ITEM FOR ENVIRONMENTAL COMMISSION AGENDA

NAME & NUMBER OF PROJECT: 1514 W Koenig Lane Office Building; SP-2019-0027CT

REQUEST: Variance request is as follows:
Request to vary from LDC 25-8-261 to allow construction in the Critical Water Quality Zone

Re: Environmental variance requests for 1514 W. Koenig Lane Office Building, Austin, Texas 78756
Case: SP-2019-0027C

Figure 2. Photos of Hancock Branch at Arroyo Seco and Koenig Lane

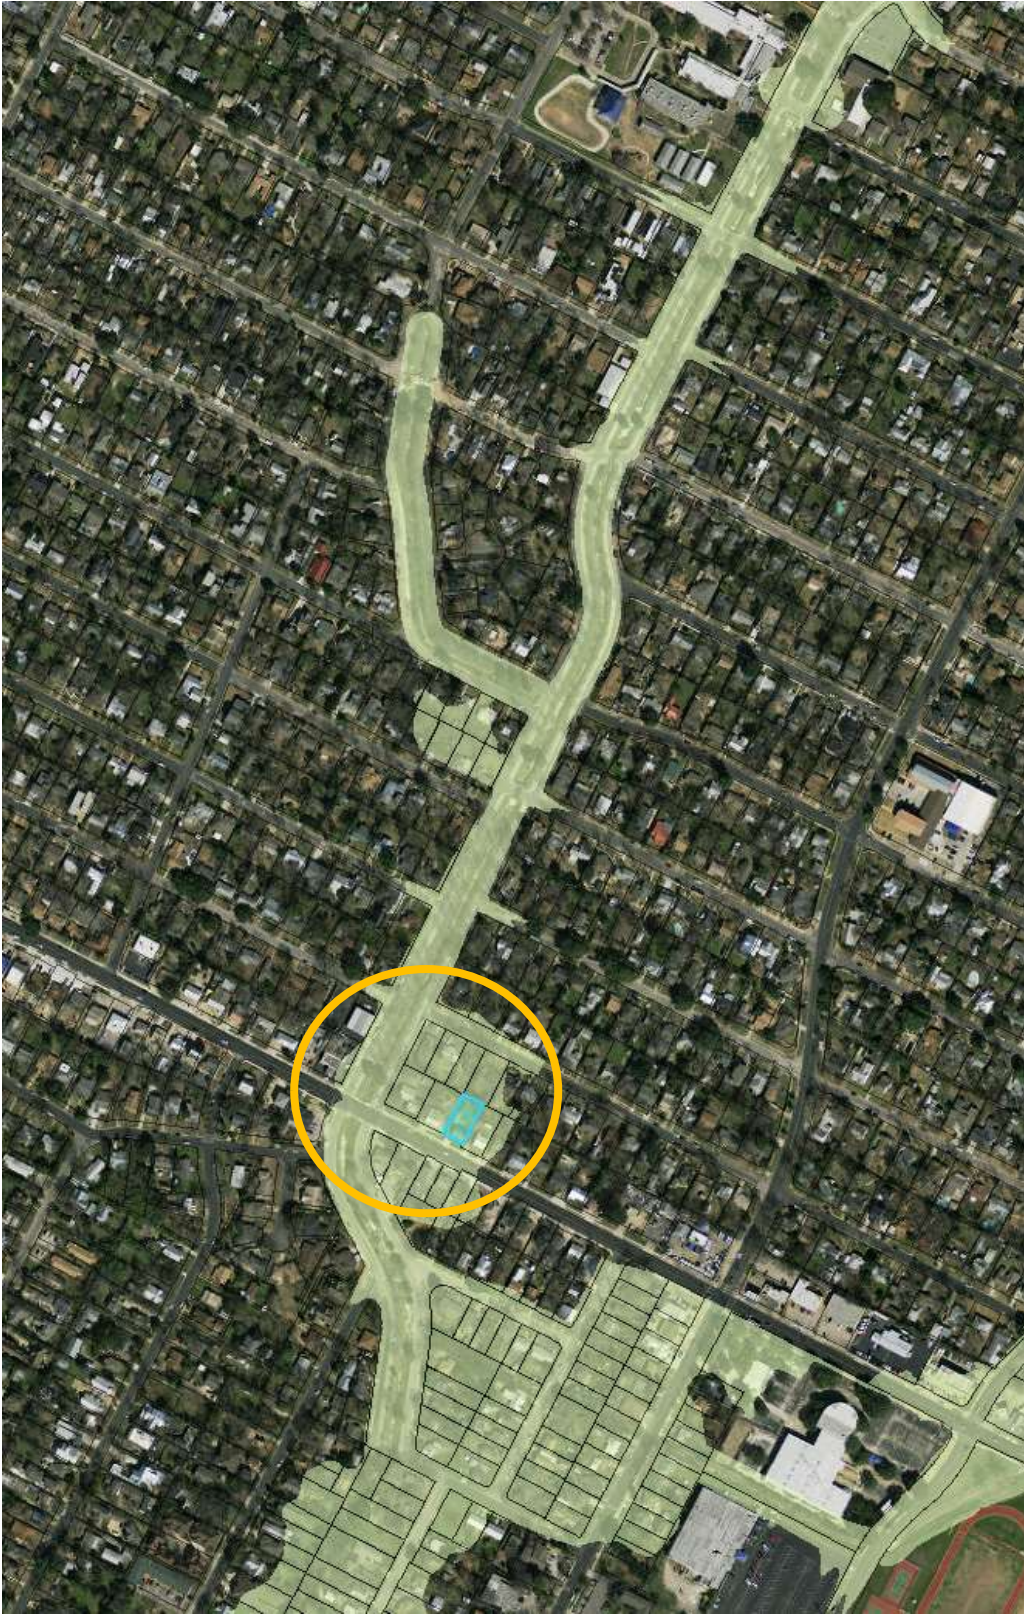
Figure 2 shows photos of the creek consisting mostly of vegetation that is periodically mowed down for maintenance. There are no plans to remove Koenig Lane, Palo Duro Canyon, and Arroyo Seco roadways and the existing commercial and residential impervious cover to restore the CWQZ to a natural condition.
